# KENWOOD

## SERVICE BULLETIN AMATEUR RADIO

SUBJECT TS-950S/SD RECEIVER NOISE

05/29/90

### AF UNIT X49-3020-00

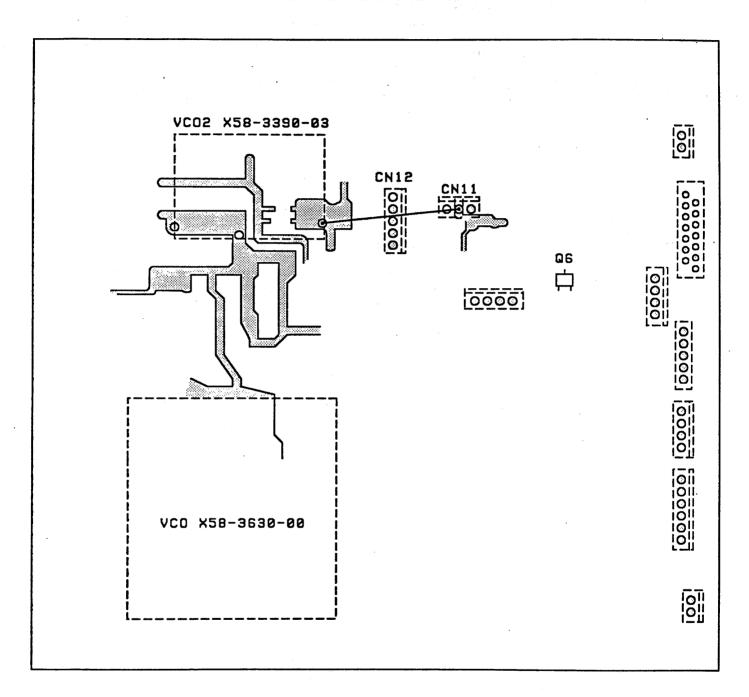
About 1mV of noise is present at the speaker or headphone jack in the receive mode with the AF GAIN control set to minimum. If the transceiver is in the CW mode, a faint tone might also be heard through the headphones (sidetone leakage). The following modification will reduce the level of the noise and the tone.

- 1. Disconnect the power cord and antenna.
- 2. Remove the top and bottom covers (18 screws).
- 3. Locate the AF unit on the bottom of the transceiver. This is the front left board of the four boards on the bottom of the transceiver.
- 4. Remove the screws from the AF unit and disconnect the plugs as necessary to turn the board over to expose the foil side of the board.
- 5. Replace Q6 with a 2SD1757K(S).
- 6. Solder a 22 AWG jumper wire as shown in figure 1.
